Submission to Hornsby Shire Council Local Traffic Committee

## Proposing Changes to On Street Parking Conditions Surrounding New Sydney Metro Stations

## Attachment 1 – Parking Change Concept Diagrams

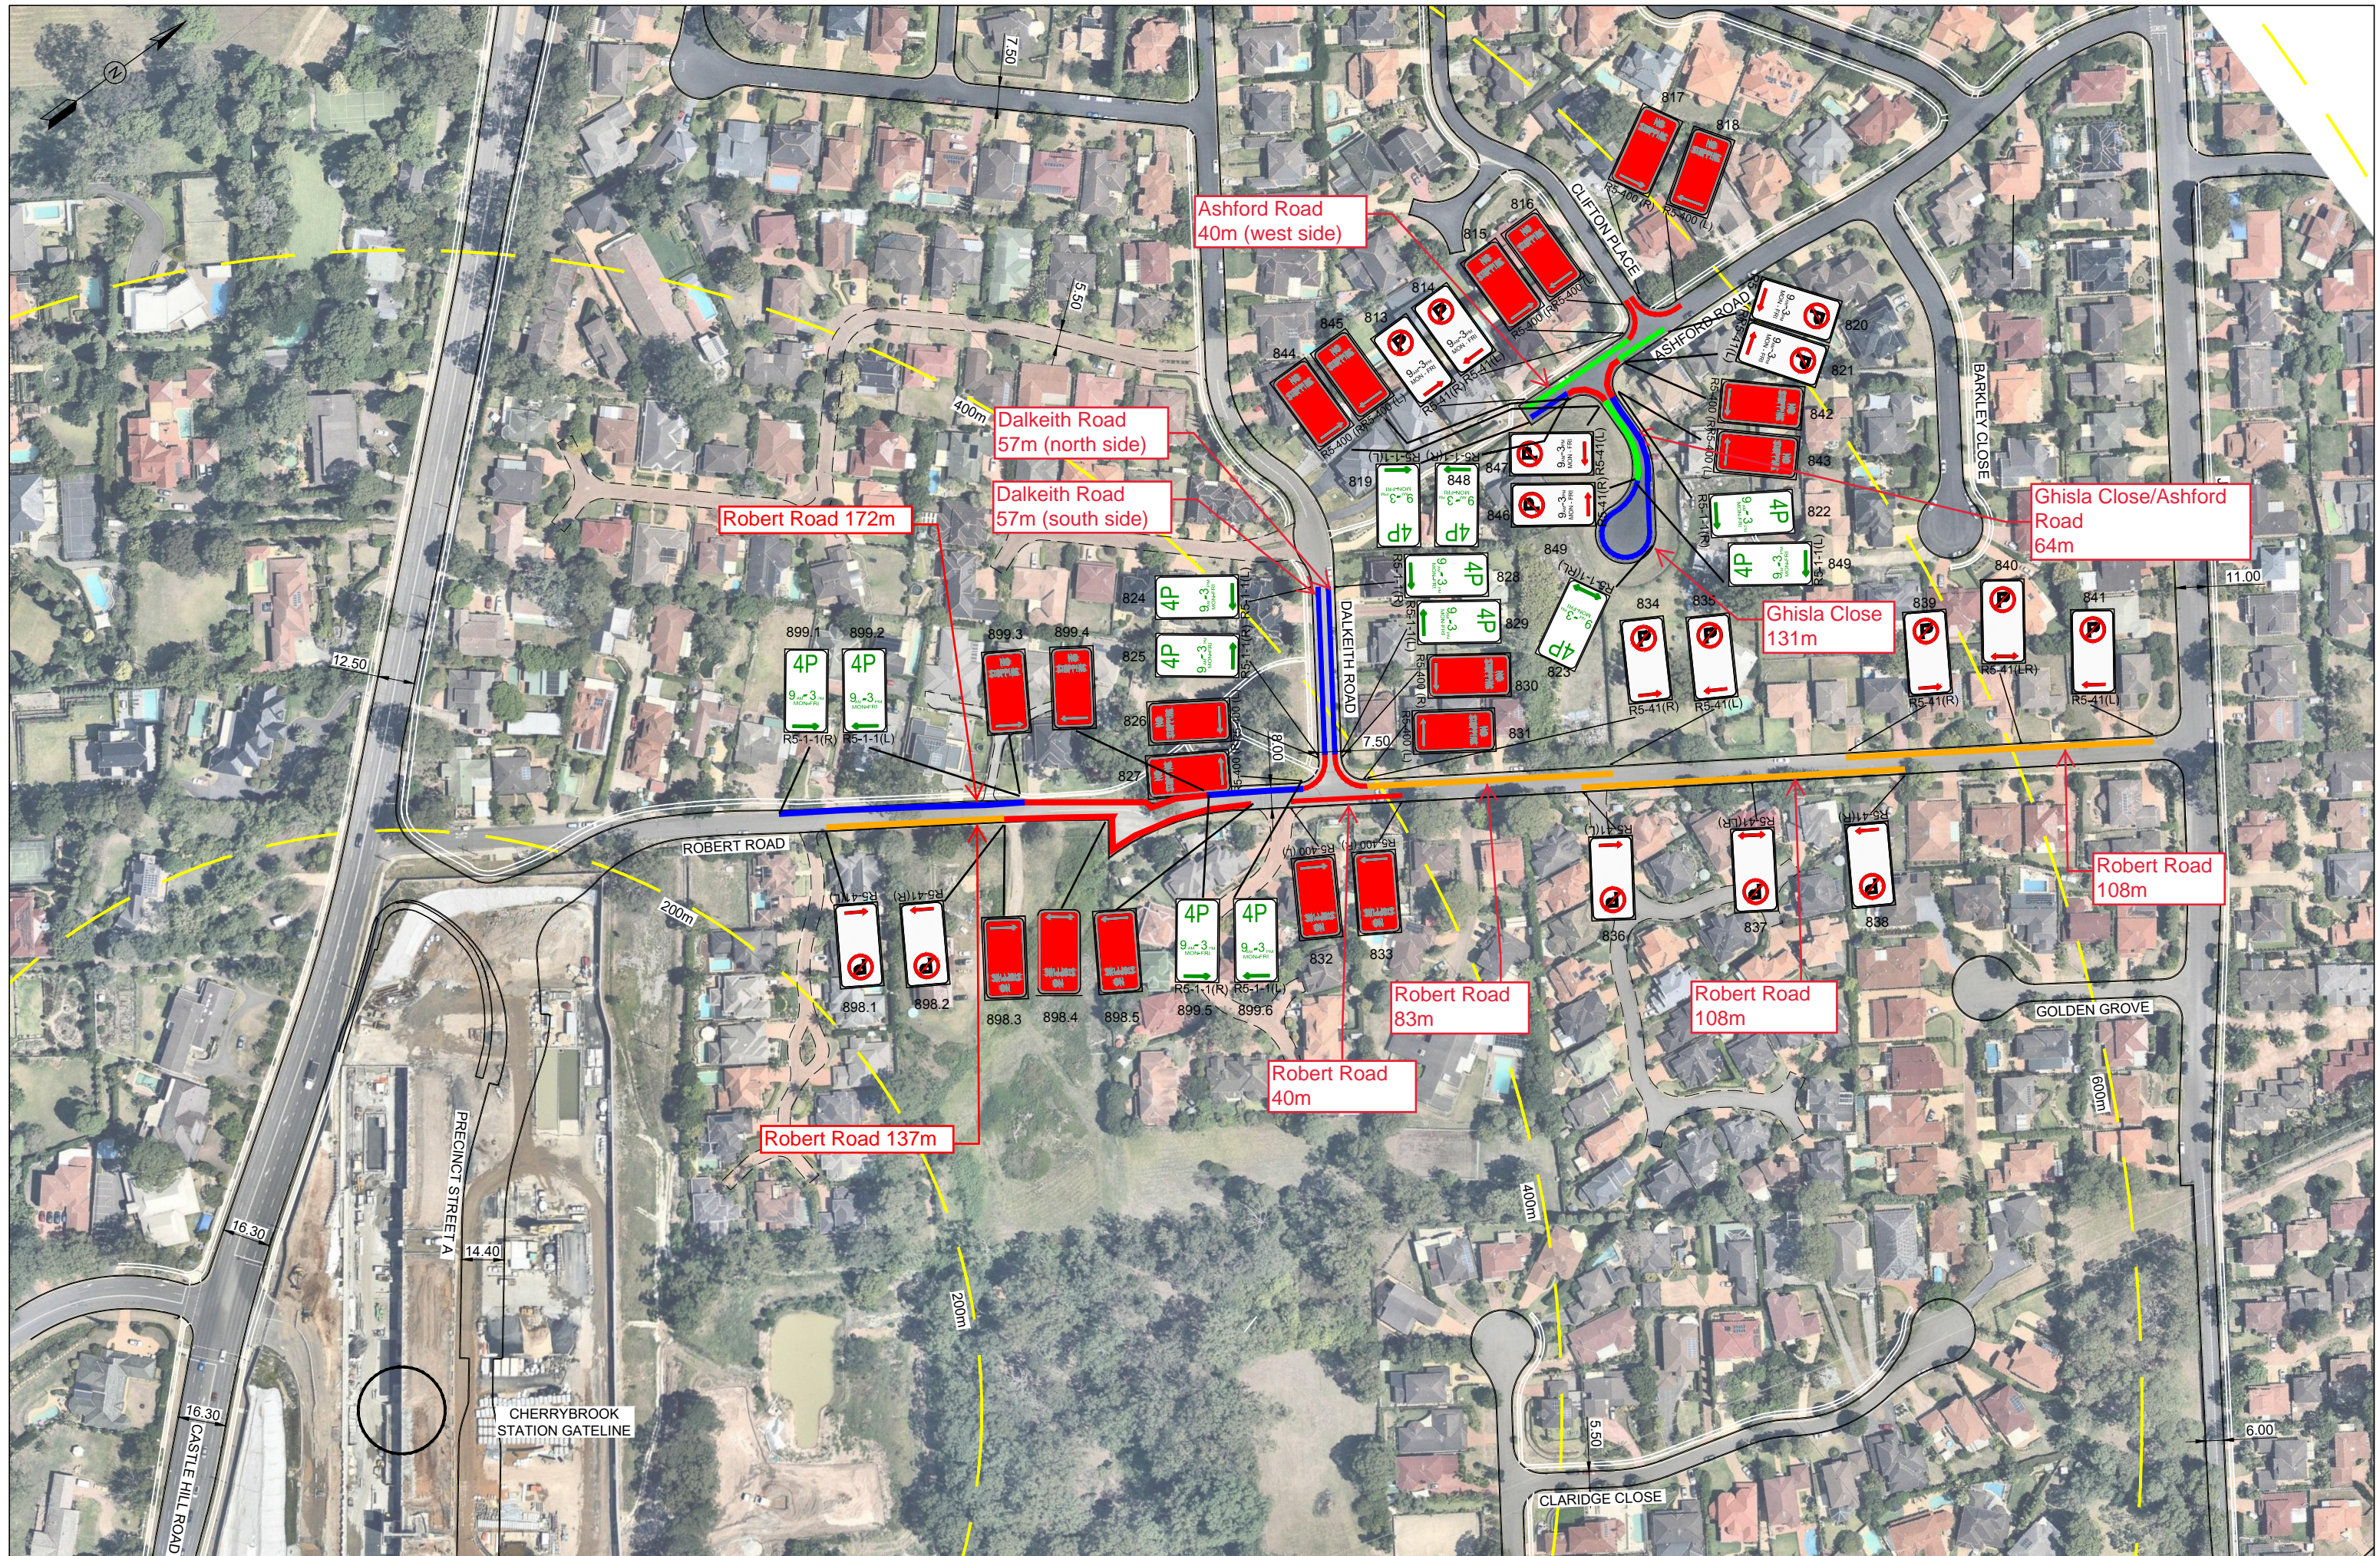
| <b>Consultation Considerations</b> | Following consultation with residents and stakeholders, Sydney Metro proposes to amend the original proposal by: <ol style="list-style-type: none"> <li>1. Changing the restrictions at the end of each cul de sac to No Parking (previously proposed to be No Stopping)</li> <li>2. Providing an unrestricted area on Fernleigh Close</li> <li>3. Extending the No Stopping restriction on the western side of Franklin Road beyond the Neale Avenue intersection (in the northern direction)</li> <li>4. Rezoning a No Parking Zone in front of Tangara School for Girls to become a No Stopping Zone</li> <li>5. Rezoning and area opposite Tangara School for Girls, initially proposed to be No Stopping, now proposed to be 'No Parking 8am-9:30am / 2:30pm-4pm Monday to Friday' to allow for pickup and drop off activity during school hours and residents parking at other times.</li> </ol> <p>Sydney Metro will continue to monitor parking on streets for 12 months following commencement of Metro services to inform any further parking restrictions that may be considered.</p> |

Residents were concerned about the impact of commuters parking in their streets and wanted on-street parking protected for resident use only. The majority of submissions stated that they did not support the parking restrictions for Cherrybrook Station as proposed. The majority of submissions requested that a resident parking scheme be implemented to protect the ability of residents to park in proximity to their homes. The majority of these requests came from residents on Ridgmont Close, Franklin Road, Fernleigh Close and Claridge Close, although requests were also received from residents of Curtis Close, Chapel Close and Neale Avenue.

Inala's Dulkara centre for Life Skill and the Arts also requested the provision of special parking permits for restricted parking areas as the street frontage in front of 118 Franklin Road is proposed as 'no stopping' and is used by staff for parking under the current parking restrictions. They also need to hold NDIS departmental meetings for clients and families at various times, and further parking spaces are needed on the days these occur. The proposed restrictions would not accommodate these requirements.

Several residents requested that the proposed parking restrictions be swapped to the other side of the street due to the location of existing footpaths. The proposed restrictions placed 'no parking' restrictions on the side of the street with the footpath and the 4 hour parking on the side without. These requests were from residents of Claridge Close and Fernleigh Close but this situation would also be applicable to Ridgmont Close as well.

Several residents in Curtis Close also requested that Curtis Close be considered for parking restrictions. They have recently experienced parking issues with construction employees working on Cherrybrook Station and have noted that they are within a 5-7 minute walk of the station.

| STREET NAME   | REQUESTED CHANGES  | NO. REQUESTS |
|---|--|--------------|
| Ridgemont Cl, Franklin Rd, Fernleigh Cl & Claridge Cl | Provide resident parking permits to allow residents to be exempt from timed parking restrictions.  | 29           |
| Claridge Close  | Limit parking restrictions to 3 hours instead of 4 hours.  | 1            |
| Claridge Close  | Change location of restrictions to other side of the street - relocate 4P to the western side of Claridge Close (odd-numbered side) where there is an existing footpath.   | 1            |
| Fernleigh Close                                       | Change location of restrictions to other side of the street - relocate 4P to the western side of Fernleigh Close (odd-numbered side) where there is an existing footpath.  | 2            |
| Curtis Close  | Request that Curtis Close is considered for inclusion in the parking management plan for time restricted parking, (excluding residents).   | 3            |
| Franklin Road   | Upgrade Franklin Road to accommodate additional traffic and parking demand.  | 1            |
| Franklin Road   | Add no stopping or no parking on the western side of Franklin Road between Neale and John Road.  | 2            |
| Neale Avenue  | Extend restricted parking along Neale Avenue from Franklin Road to Paxton Crescent, (with resident exemptions).  | 4            |
| Neale Avenue  | Add no stopping either side of Neale Ave from Franklin Road to Fallows Way - in order for traffic to be able to turn left into Franklin Road (toward the metro) while a vehicle is waiting to turn right into Franklin Road. | 1            |

**CHERRYBROOK STATION - ROBERT ROAD  
PROPOSED PARKING CHANGES - EARLY 2019**

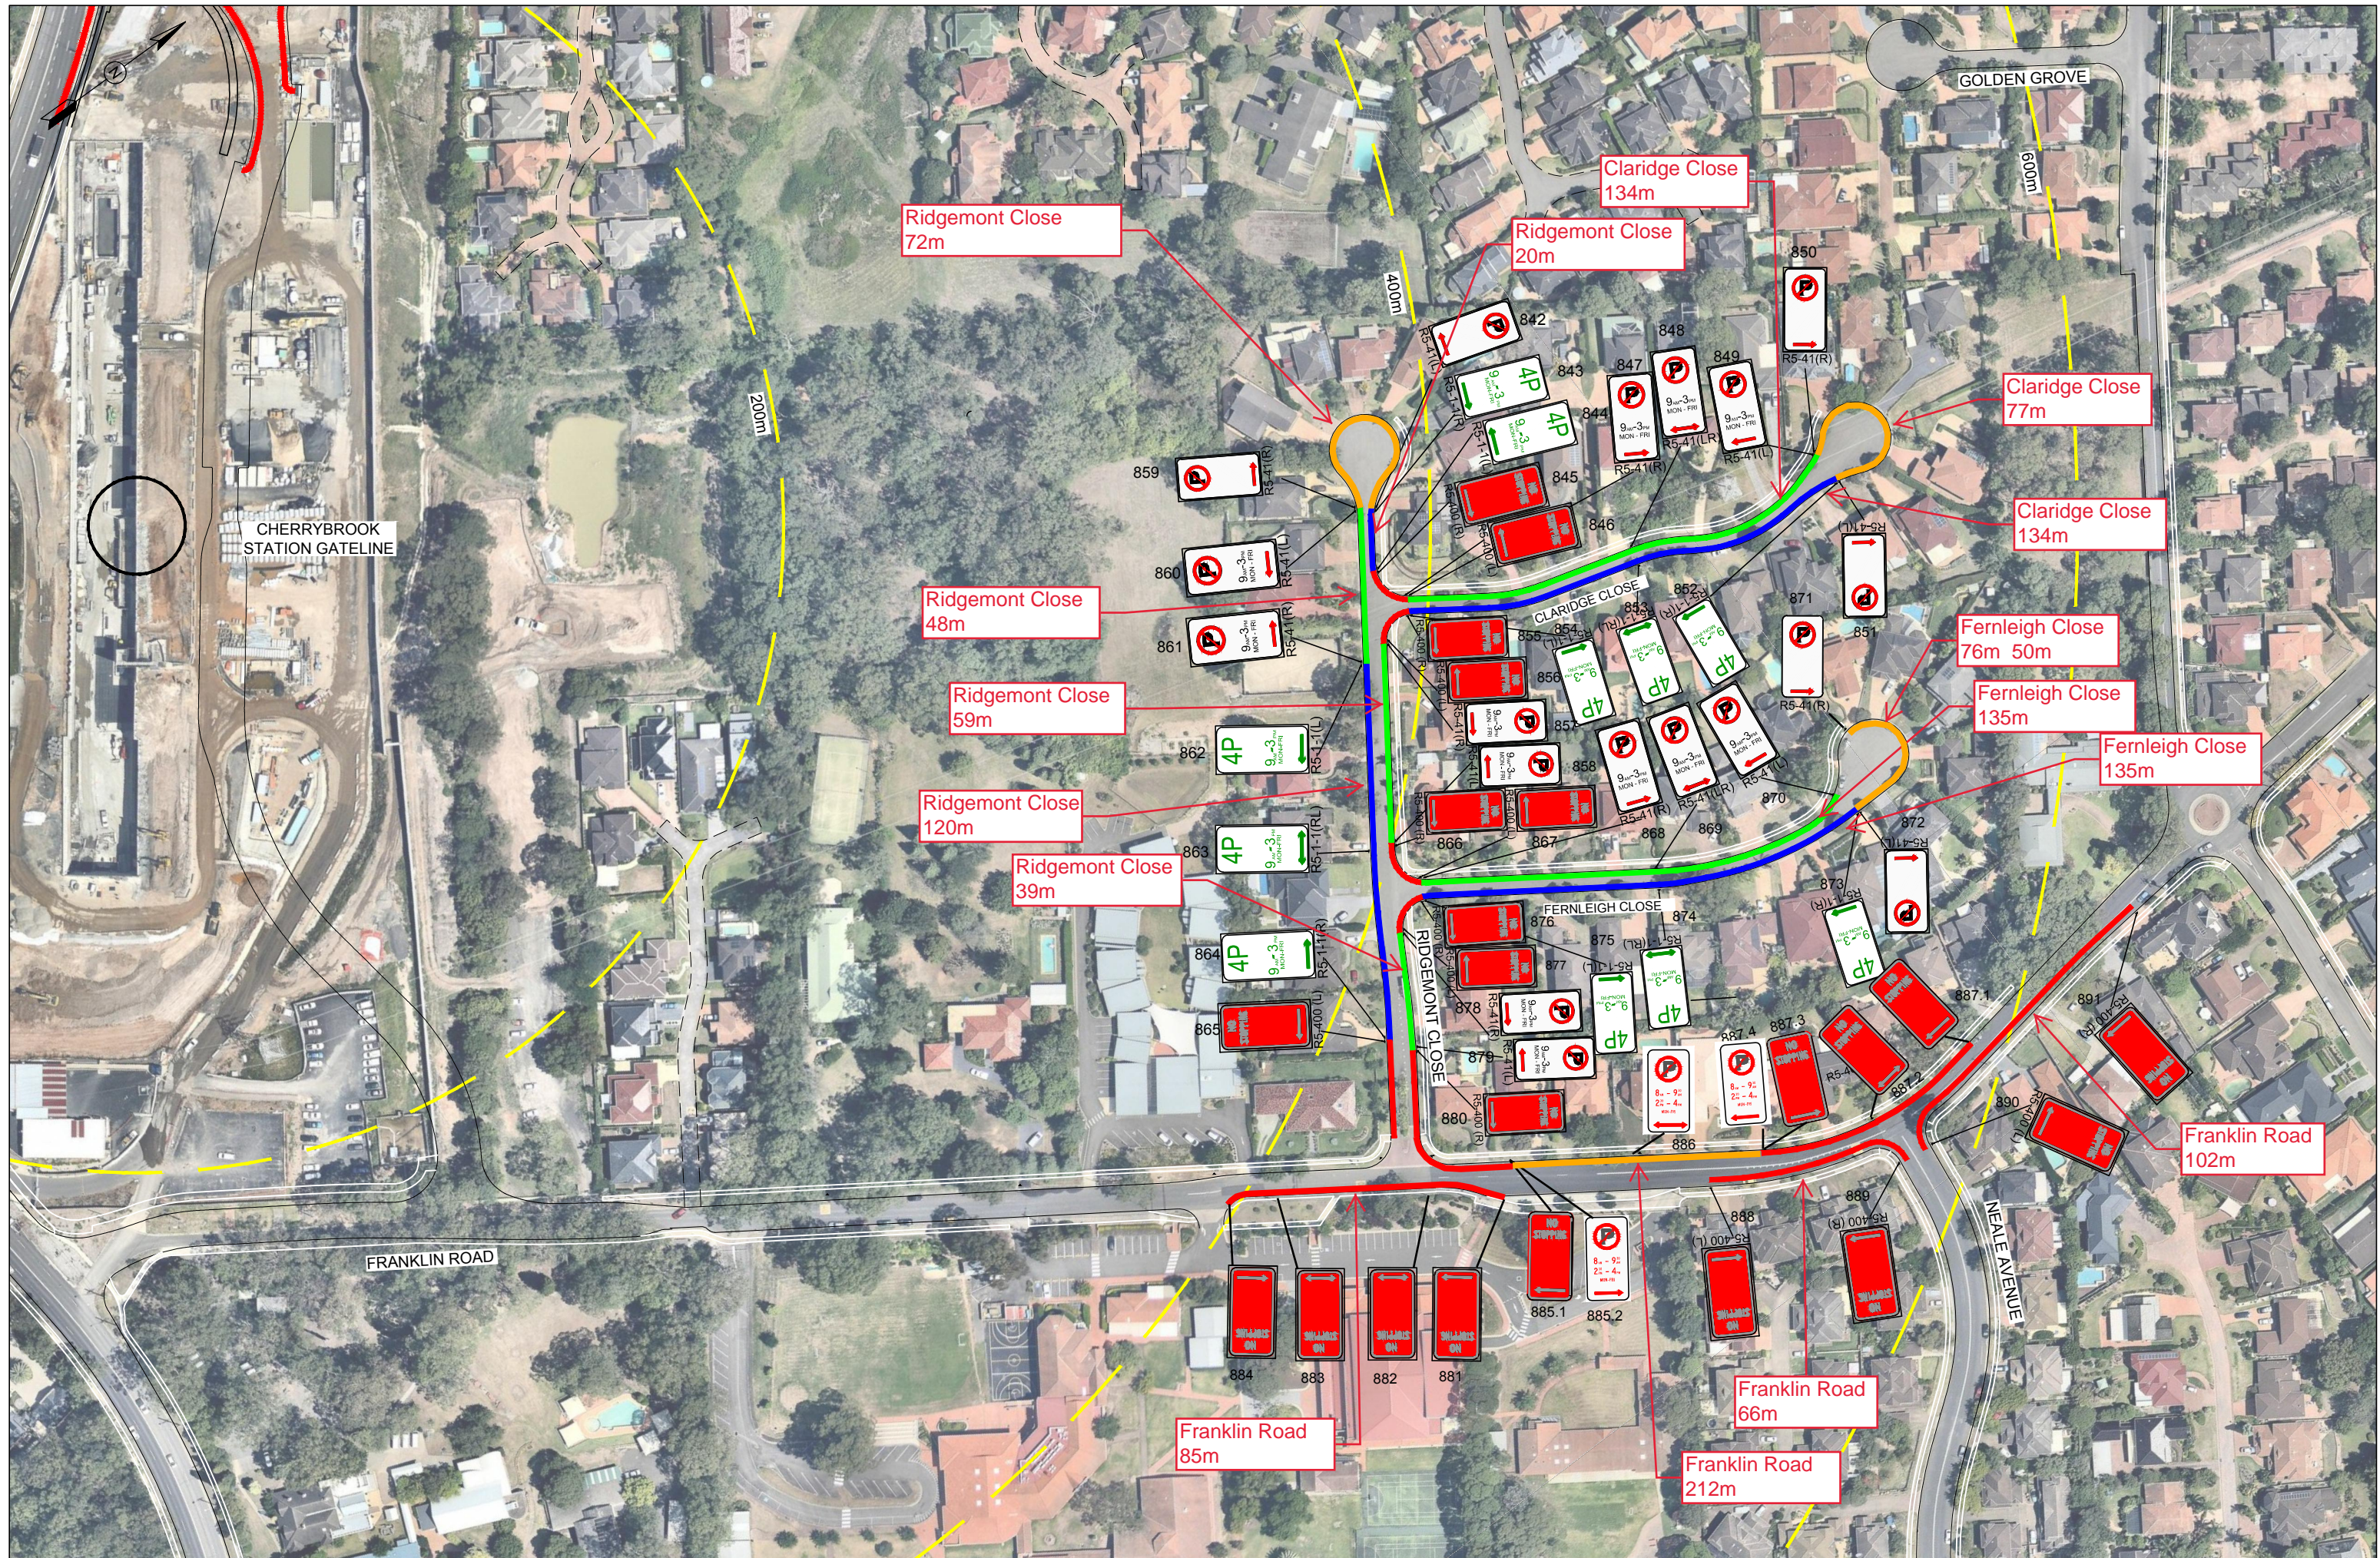
| <b>Consultation Considerations</b> | Following consultation with residents and stakeholders, Sydney Metro proposes to amend the original proposal by: <ol style="list-style-type: none"> <li>Moving the no parking zone on Ghisla Close from the northern side to the southern side.</li> <li>Adding 4P, No Parking and No Stopping along Robert Road between Oliver Way and Dalkeith Road. This area is in the 200m-400m radius from the station and was not captured in the initial assessment as not being treated by the station builder.</li> </ol> <p>Sydney Metro will continue to monitor parking on streets for 12 months following commencement of Metro services to inform any further parking restrictions that may be considered.</p> |

While there was a level of support for the proposed parking changes around Robert Road, a number of further changes were suggested, including that ‘no parking’ restrictions are located on only one side of Robert Road rather than staggered across both sides. There was also some concern that allowing parking on both sides of Dalkeith Road may restrict access for residents and that the 4 hour parking restrictions would reduce availability of parking spaces for park users and wanted to see the time restrictions reduced to 2 hours.

| STREET NAME   | REQUESTED CHANGES   | NO. REQUESTS |
| Robert Road   | Request that Robert Road be designated as "parking only for the Residents of Robert Road" or provide resident parking permits.  | 5            |
| Robert Road   | Request that 'No parking' restrictions be located on only one side of Robert Road rather than staggered along both sides.   | 4            |
| Robert Road   | Install 'no stopping' signs at the intersection of Robert Road and John Road (to indicate statutory no stopping distances).   | 1            |
| Robert Road   | Request for 'No parking' restrictions on both sides of Robert Road between the top of the rise to John Road due to sight lines.   | 1            |
| Robert Road   | Request that 'No Stopping' zones at the Robert Road and Dalkeith intersection be extended further south along Robert Road to at least the Robert Road 'chicane'.                    | 1            |
| Robert Road   | Request that timed parking restrictions on Robert Road be limited to 3hrs.  | 3            |
| Robert Road   | Introduce restricted parking ('no parking') on both sides of Robert Road.   | 2            |
| Dalkeith Road | Reduce timed parking restrictions on one side of Dalkeith to 2 hour parking and prohibit parking on the other side of Dalkeith.   | 2            |
| Dalkeith Road | Install No Stopping signs on Dalkeith between Dunraven Way and Rochford Way to reinforce the no stopping requirement (existing double white lines).                                 | 2            |
| Dalkeith Road | Restrict parking on Dalkeith to 'no parking' on both sides of the road.   | 1            |
| Ghisla Close  | No parking at all times should be designated to any parking spaces (on the opposing kerb) directly across each resident's driveway as it is an obstruction when a car is reversing. | 1            |
| Ghisla Close  | Extend 4P and 'no parking' on Ghisla Close to 9am-12pm on Saturdays.  | 1            |
| Ghisla Close  | Provide resident parking permits to allow residents to be exempt from timed parking restrictions  | 1            |

| Ashford Road | Request for 'no parking' at any time on the eastern side of Ashford Road between the corner of Ghisla Close and No. 17 Ashford Road (in conjunction with resident parking only on the western side of Ashford Road between the corner of Clifton Place and No. 20 Ashford Road or resident parking permits). | 1 |
